ōLiv 50TH RESIDENCE
Seattle, Washington

GGLO
CORE Spaces
Recommendation Meeting 01
Meeting Date: Oct 23,2023

Site B - Mid-rise
SDCI Project Number : 3039651-LU
3039717-EG

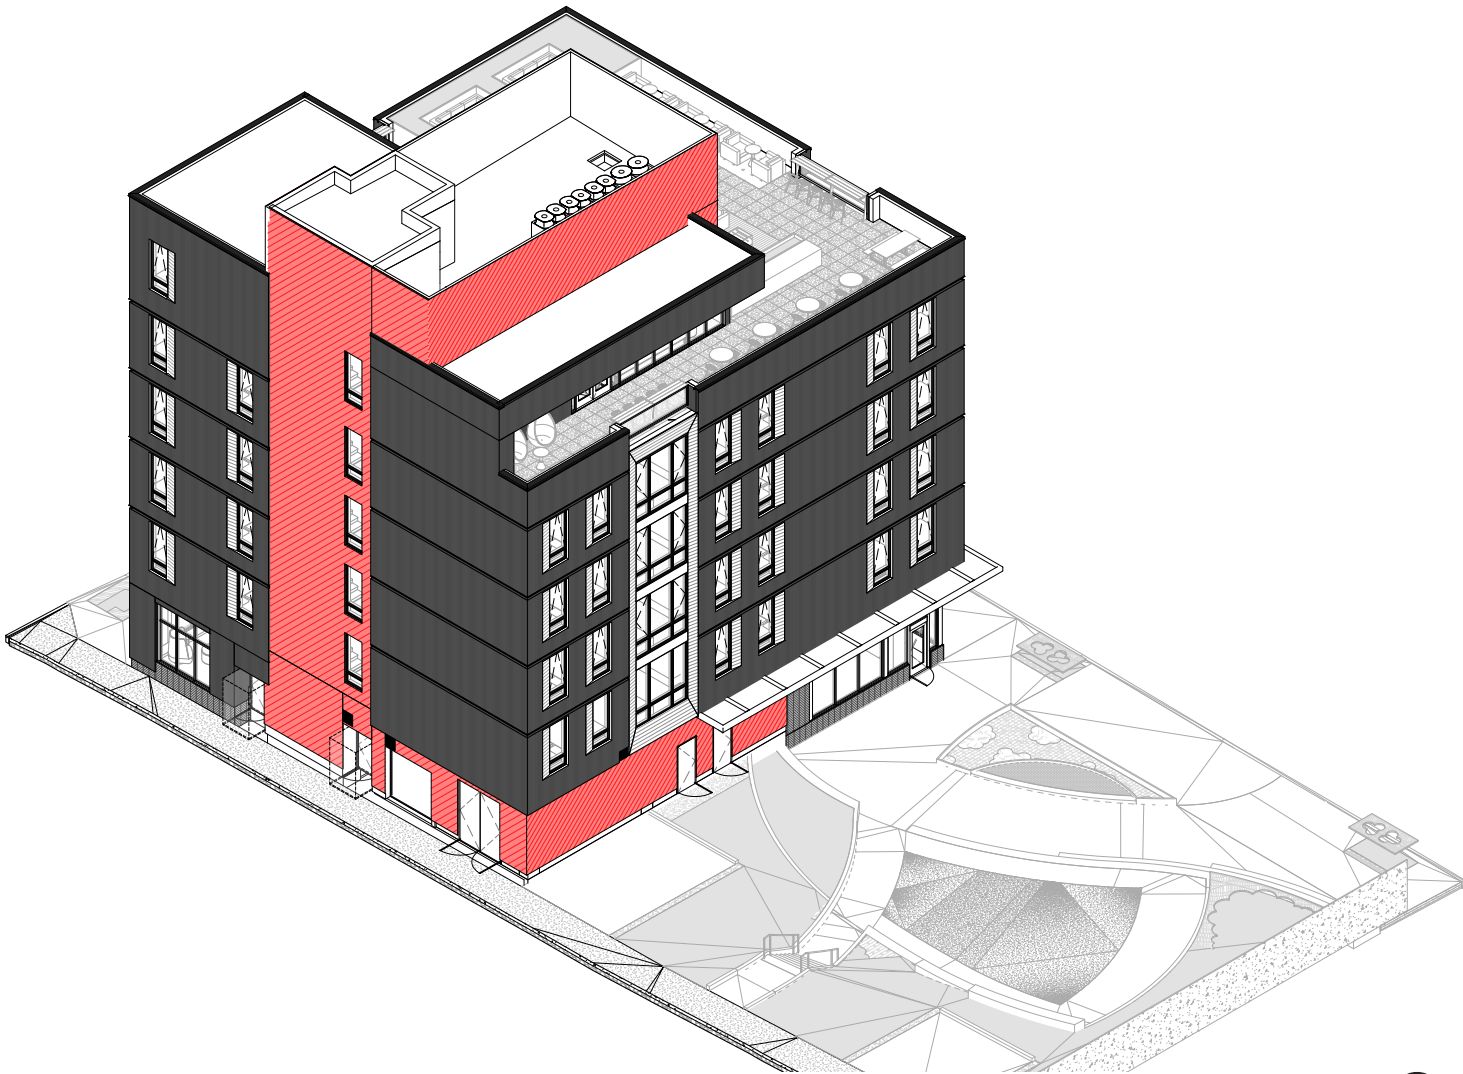
B - The Board questioned how this midrise and the high-rise project are intended to relate along the alley environment. The Board requested further development of the relational material concept along the alley of the Recommendation phase, which may include artwork, color, etc.

The northern portion of the alley facade maintain a high degree of visibility, providing views and light into the alley.

The midrise back of house lines up with the program in the adjacent tower. A mural along this portion is proposed as a way to reengage the pedestrian.

SITE PLAN

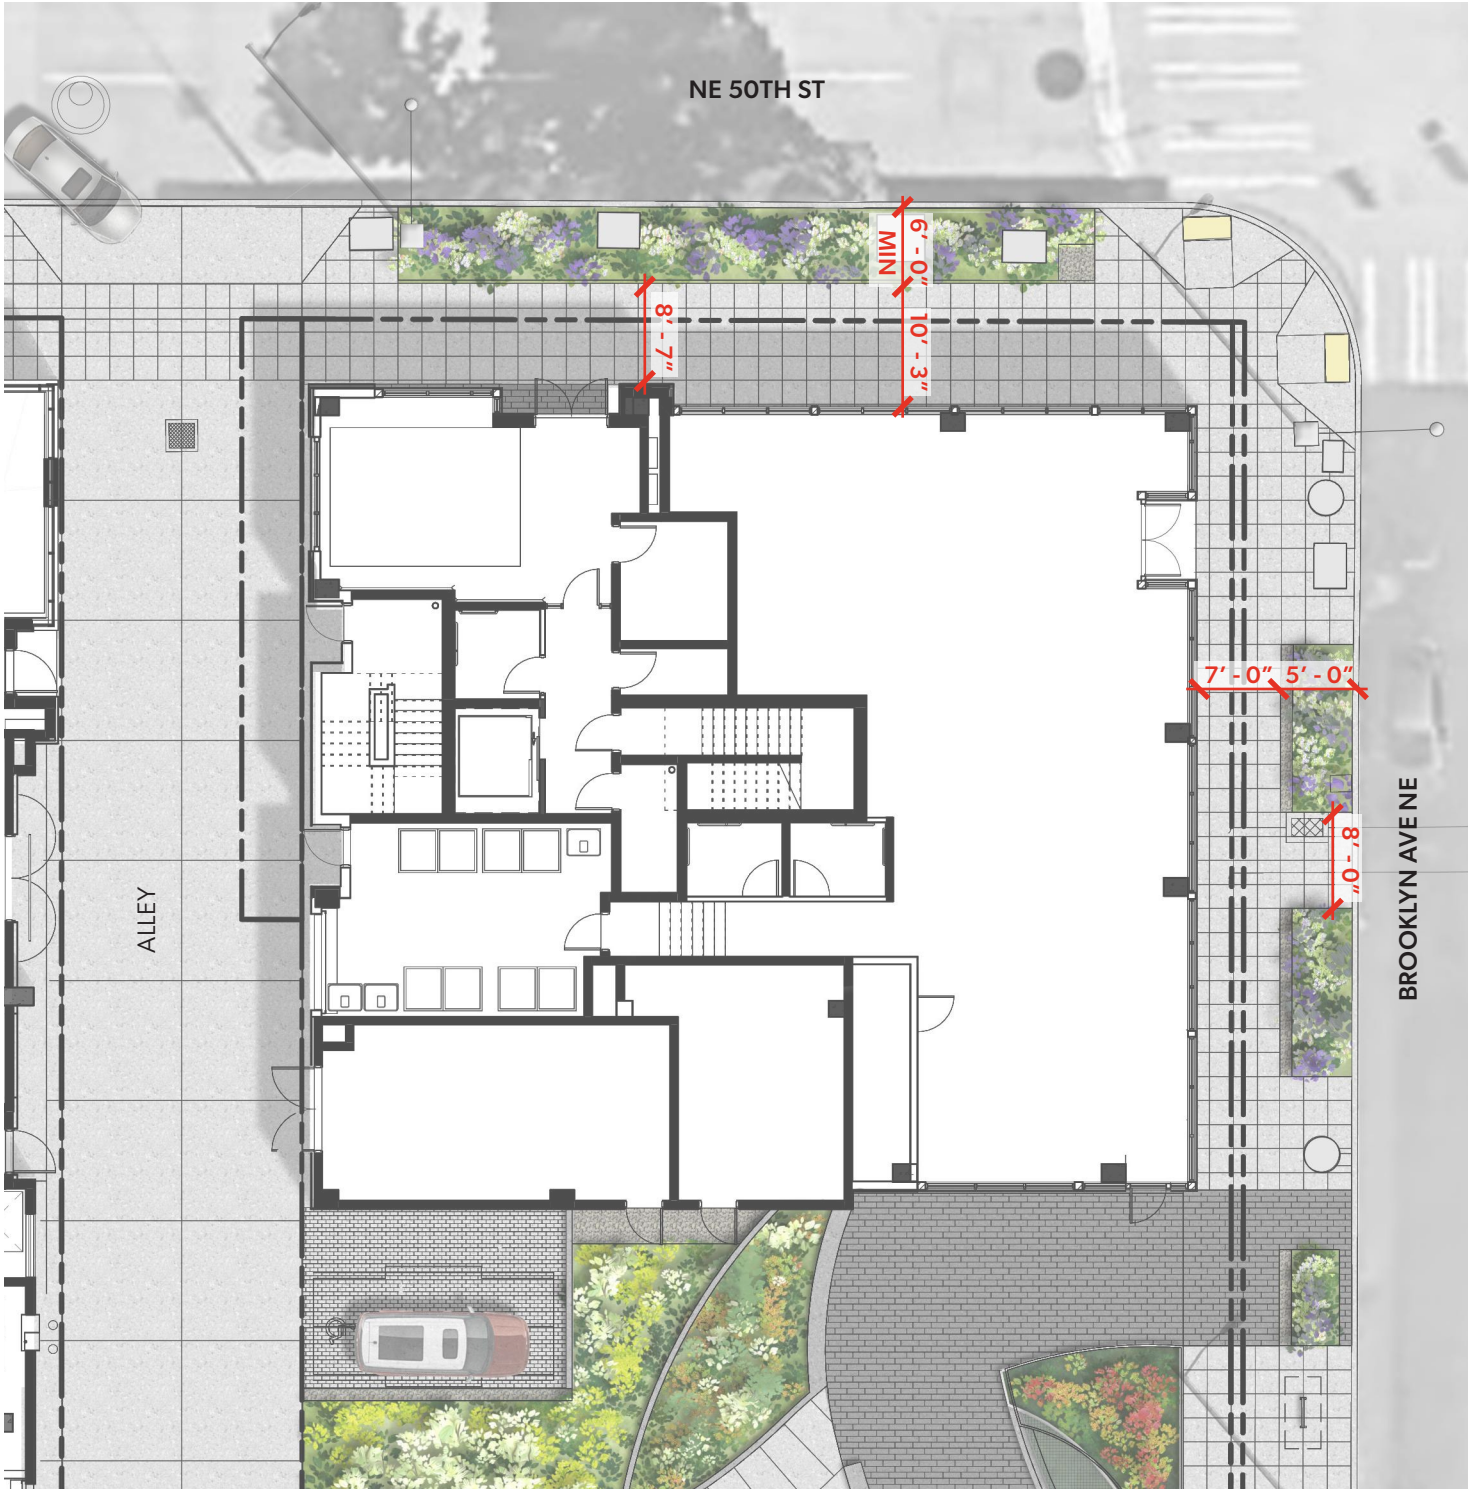
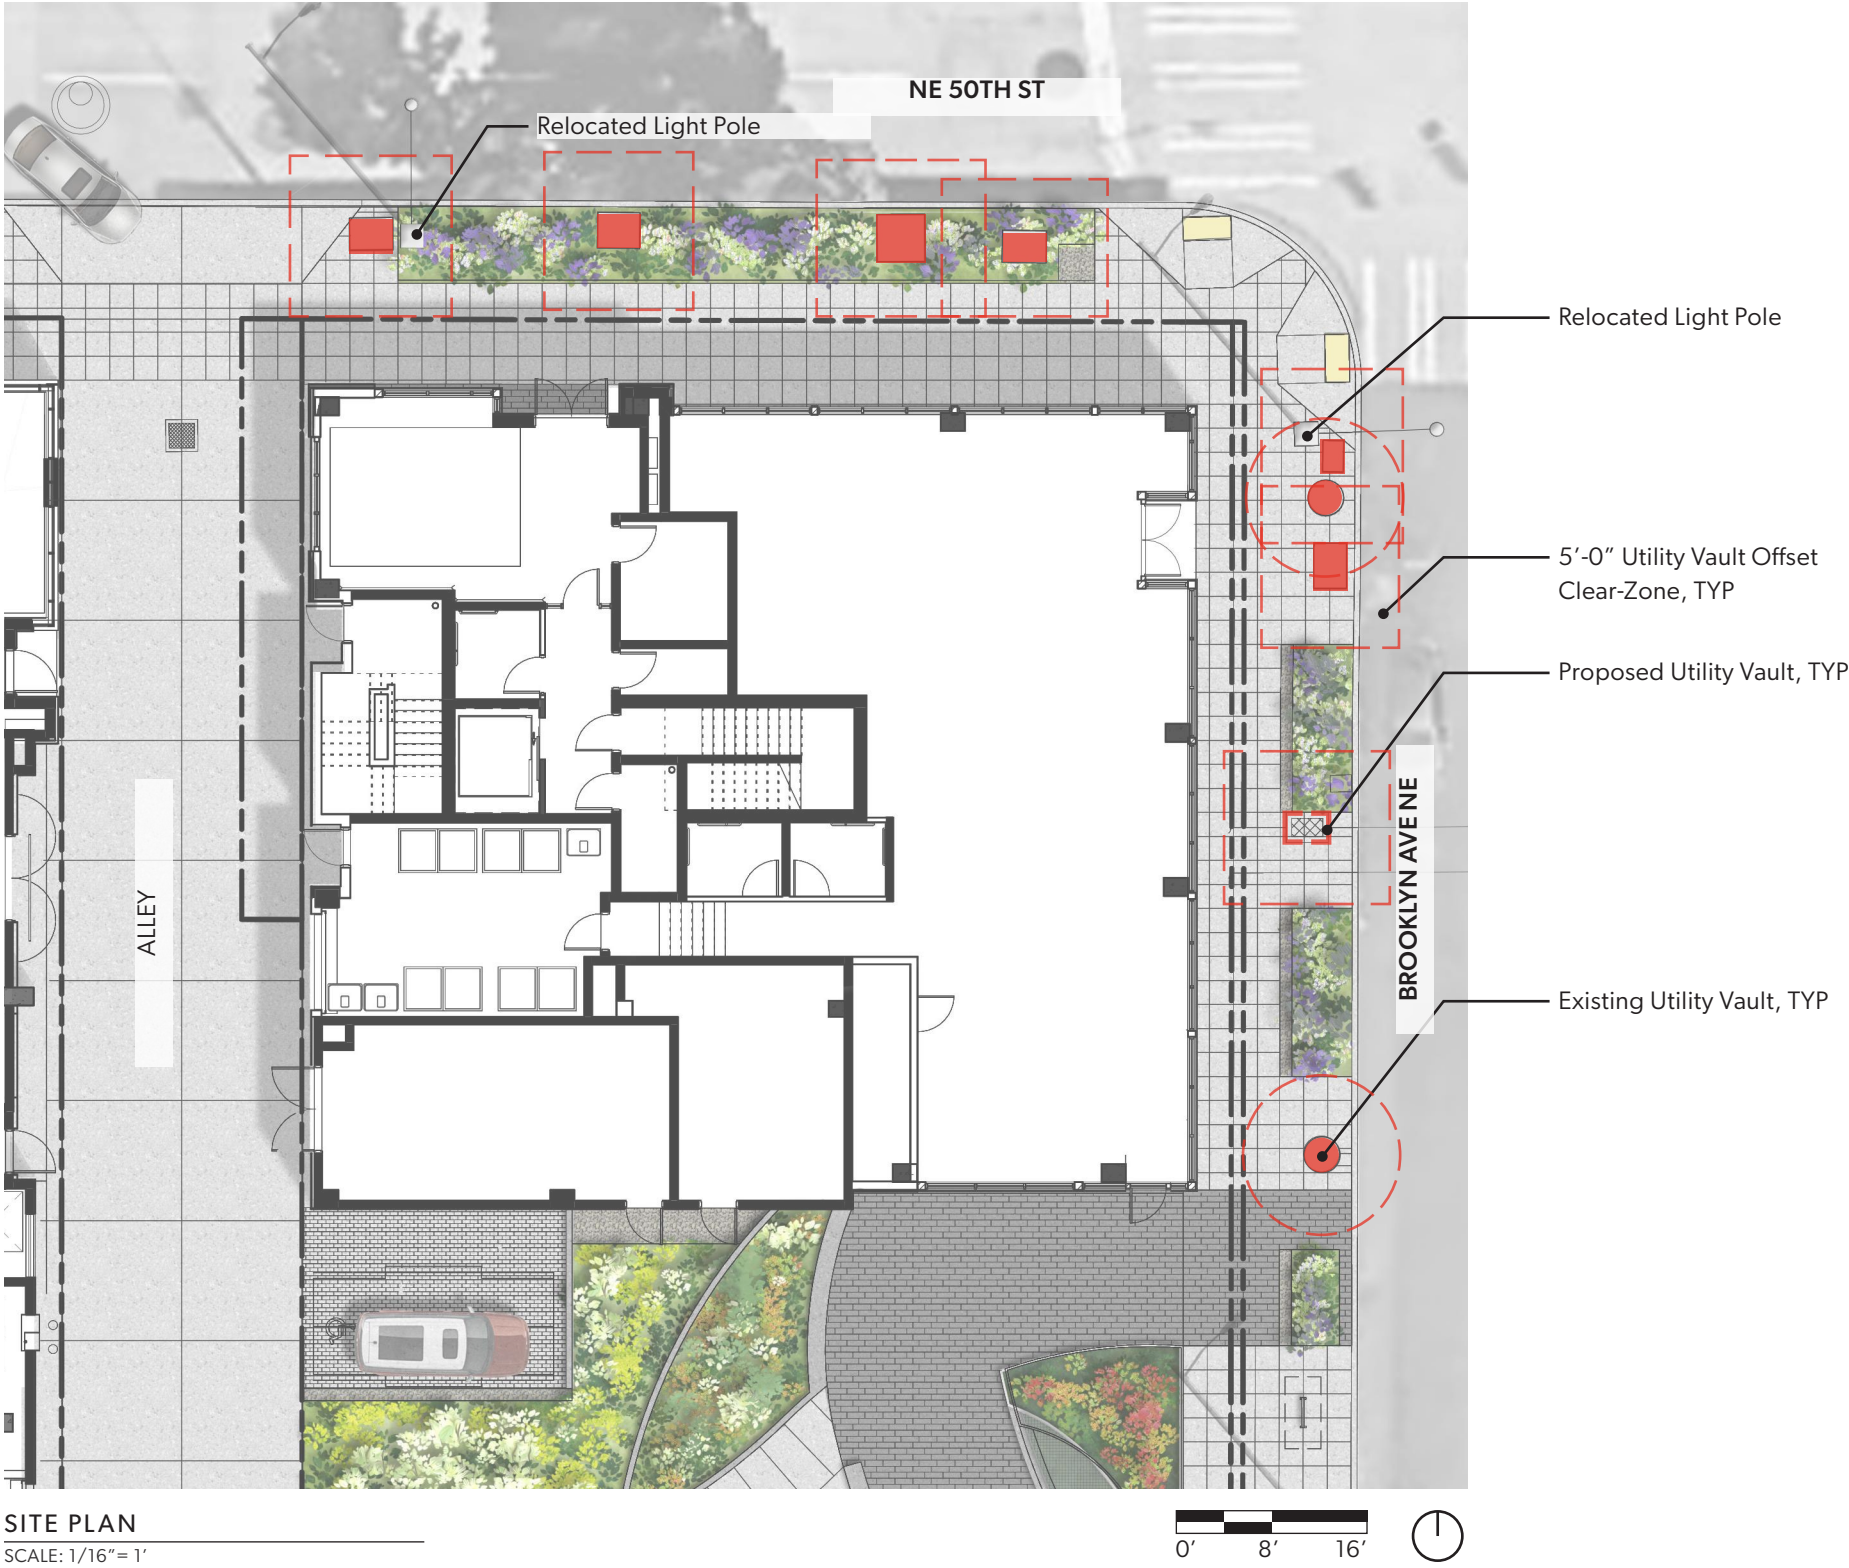
B - The Board questioned if there were requirements for the Green Street development along Brooklyn Ave. They also questioned the larger setback along the 50th St sidewalk but not along Brooklyn Ave, where the spill over from the commercial entry will occur. The Board ultimately supported the proposed approach to streetscape design, which provides wider than required sidewalks for the busy pedestrian location. They specifically supported the setback of Level 1 at the commercial unit along both street frontages that allows extra space along the public realm.

The Design Teams approach to the green street includes wider than required sidewalks, and generous planting where possible, and the addition of street trees. We have also provided access to the curb in strategic locations to allow for drop-off and rideshare to serve the retail space. Unfortunately there are several existing vaults and manholes that had required offsets , preventing further amenitization of the streetscape.
